Technical Bulletin

Model
911C2/C4

Subject: Radio Interference from Alternator

Number
9101

Figure 1

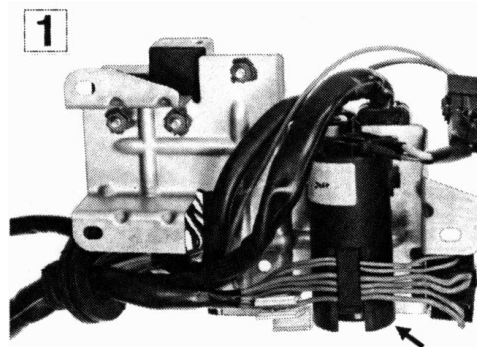
Repair Information: An interference suppression filter may be installed on the engine compartment fuse/relay board to alleviate this condition (arrow, Figure 1).

It is installed on all vehicles from production date:
November 15, 1990

VIN: WP0AB296 _ MS 41 0989 — Coupe
WP0BB296 _ MS 44 0438 — Targa
WP0CB296 _ MS 46 1025 — Cabriolet

Figure 2

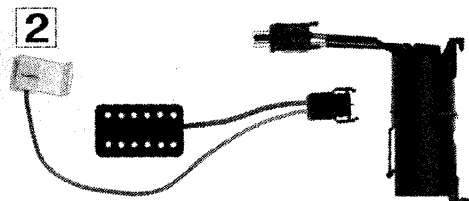
- b. Ground wire for booster.
Disconnect ground wire from booster (term.1 - brown wire) install new 4mm diameter wire and connect to ground point XX on seat cross member under the right seat.
- c. Check ignition wires for correct routing and installation. Spark plug connectors must be tight.
- d. Interference suppression filter and additional wiring harness (Figure 2) can be installed in 911 Carrera 2/4 prior to the VIN numbers on page one.

Figure 3

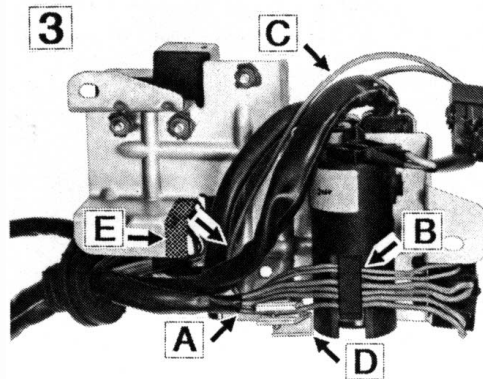
4. Cut wiring protection sleeves for wiring harness leading to fuses approximately 10cm and remove (Figure 3, arrow A).

Careful, do not cut wiring

Figure 4

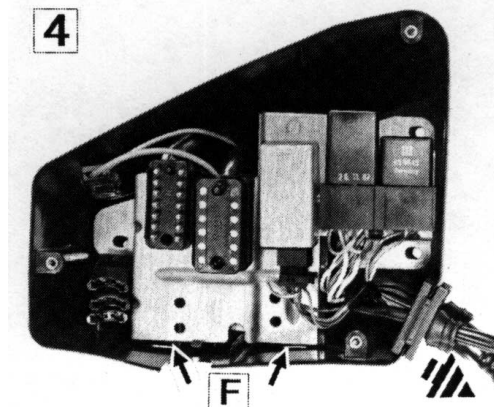
Note: When installing carrier plate, make sure the plate contacts the stops on the housing (Figure 4, arrow F). To achieve proper installation, it may be necessary to pull both wiring harnesses approximately 3cm towards the front (Figure 4) and to push bottom of suppression filter slightly towards the front.
